U.S. NUCLEAR REGULATORY COMMISSION

AUGMENTED INSPECTION TEAM

Report No.: 50-461/97018

Facility: Clinton Power Station

CONTACT ASSEMBLY (FIGURE 2)

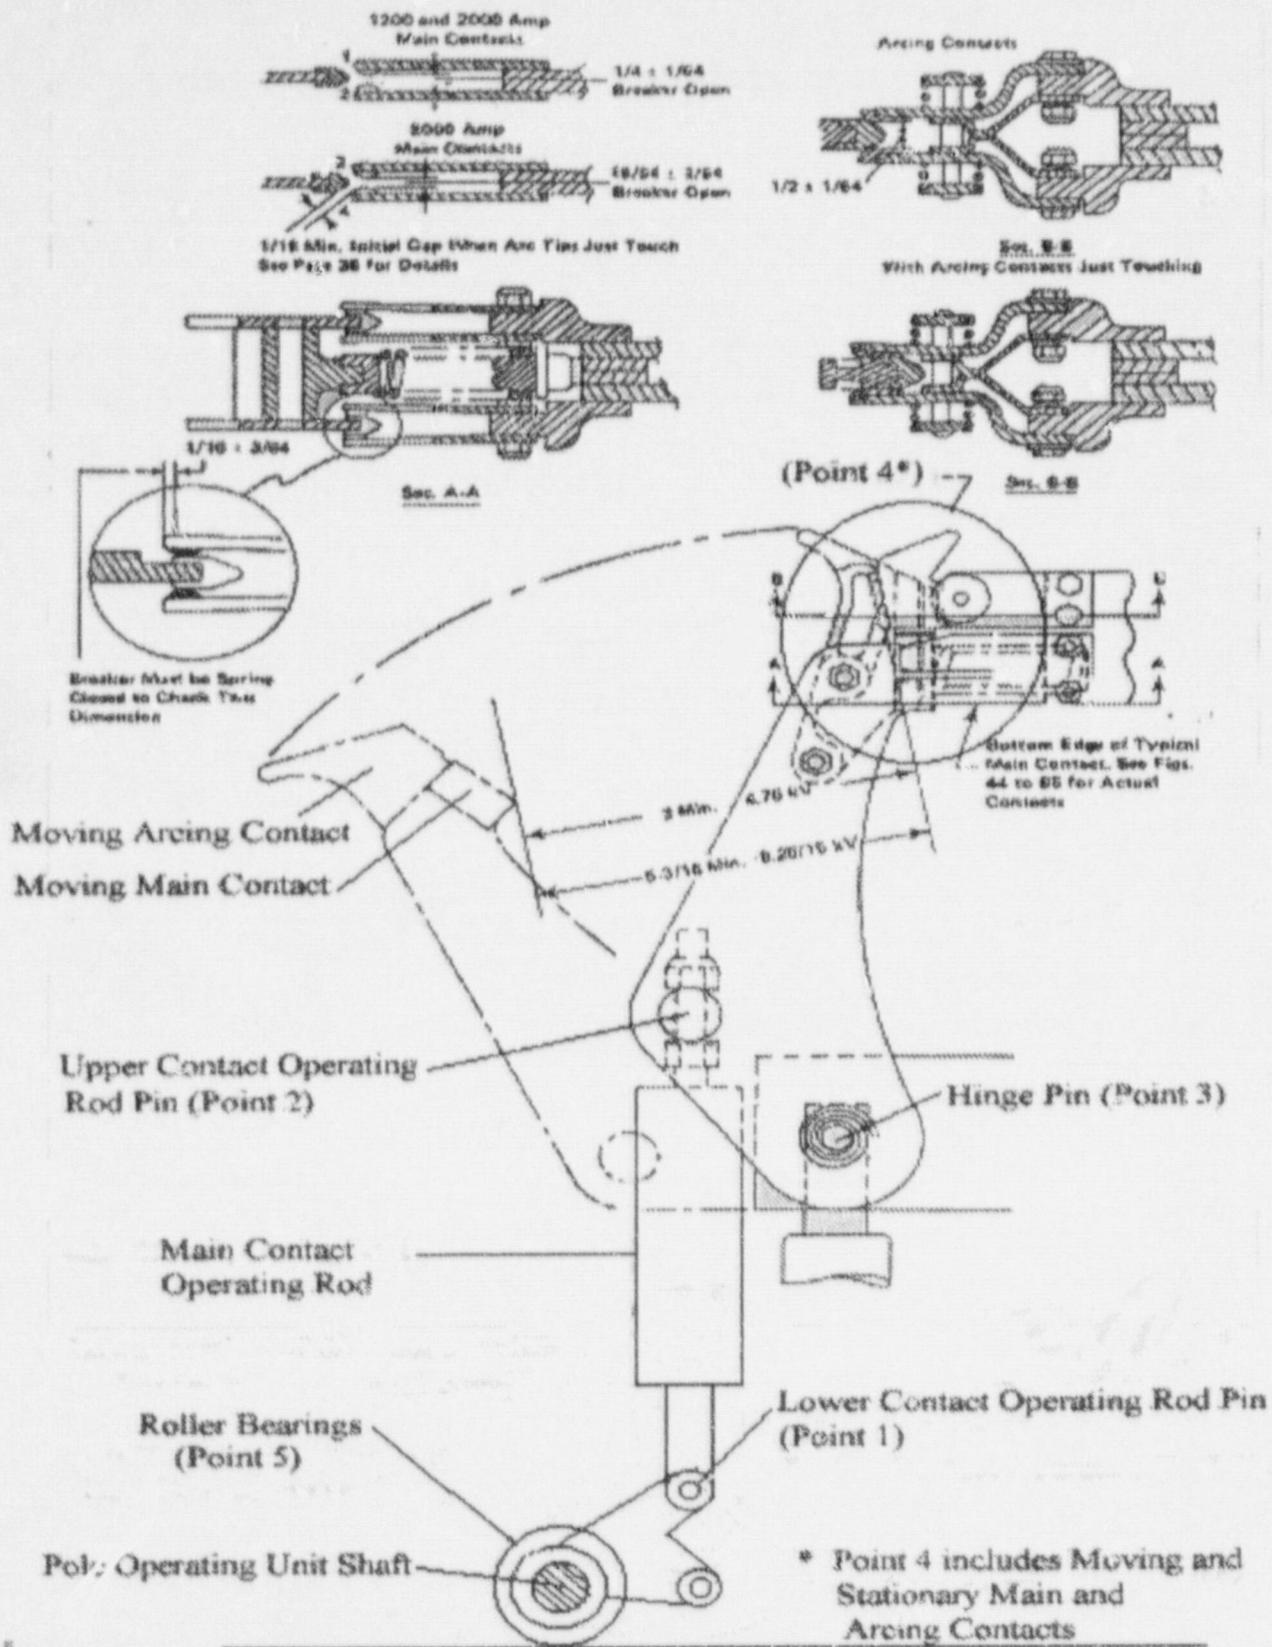
The AIT reviewed Tasks PEMRHA002 and PEMRHA501 which conducted the last full PM on RHR and RAT breakers and MWRs D75429 and D63306 that cleaned the breakers. The AIT then compared these tasks, MWRs and Revisions 15, 16 and 17 of Procedure CPS 8410.01 with the Westinghouse technical manual, Instruction Book (IB) 32-253-4B, "Instructions for Porcel-line Type DHP Magnetic Air Circuit Breakers," to assess consistency with the vendor manual. Although, the licensee used an earlier version of the vendor manual, IB 32-253-4A, which had been outdated since 1989, the different manual revisions (4A and 4B) provided similar instructions regarding lubrication. The AIT assessment of the vendor's manual is documented in Section 5.2 below. The AIT identified that these work documents generally included most of the vendor's recommendations. There were however exceptions, most notably CPS' PM procedure CPS 8410.01 did not include the vendor recommendation for lubricating the main and arcing contact surfaces (Point 4 of Figure 2).

The vendor's manual stated that lubrication of the contact surfaces (Point 4 of Figure 2) at normal maintenance intervals would be beneficial. However, the licensee overlooked this recommendation while developing their breaker maintenance procedures. Compounding the omission was the fact that previous CPS maintenance practices of using files, plastic scouring pads, and unapproved solvents on the main contacts may have removed lubricant applied at the factory. Lubrication of the upper and lower contact operating rod pins (Points 1 and 2 of Figure 2) was not mentioned in the vendor's manual or CPS' maintenance procedures. The vendor manual stated that lubrication of the

moving hinge contact point (Point 3 of Figure 2) was unnecessary unless the contacts were replaced and that lubrication of the pole shaft roller bearings (Point 5 of Figure 2) should not normally be required because these bearings were packed at the factory with a "top grade slow oxidizing grease that should last for many years." The manual further stated these bearings should remain undisturbed unless the breaker exhibited sluggishness or evidence of dirt existed. The vendor's manual also recommended that the roller bearings should be cleaned and relubricated if the parts were dismantled for some reason. Although the vendor manual described routine lubrication points, its use of wording such as "beneficial" and "for many years" did not emphasize or ascribe appropriate level of importance to these actions.

Electricians interviewed by the AIT indicated they did not lubricate Points 1, 2, 3, 4, and 5 of Figure 2. The electricians stated that during routine breaker maintenance they had used plastic scouring pads and files to dress the contacts as necessary (i.e., when pits or burrs were found). The electricians also indicated that the main contacts were not lubricated with conductive grease following maintenance. Further, the electricians stated that while they had not recently used unapproved solvents, such as Freon, on the breaker main contacts, unapproved solvents had been used on these areas in the past.

The spring forces necessary to open the breaker included the kickout, opening, and perhaps a small contribution from the buffer springs (although this was not initially considered at all by the SIT). The frictional forces considered by the SIT were the upper and lower pole operating rod pins, the moving contact arm hinge, and the moveable and stationary main and arcing contacts (Points 1, 2, 3, and 4 of Figure 2) respectively.

The as-found lubrication at Points 1 and 2 was gummy, indicating an unacceptable lubricant, and containing bright metal chips from metallic wear. Acceptable lubricant was found on Point 3. The SIT found mechanical wear on the main contacts, Point 4. The SIT concluded that larger opening forces (F_{spring}) to open the breaker were necessary to overcome increased frictional forces created by the mechanical wear on the contacts.
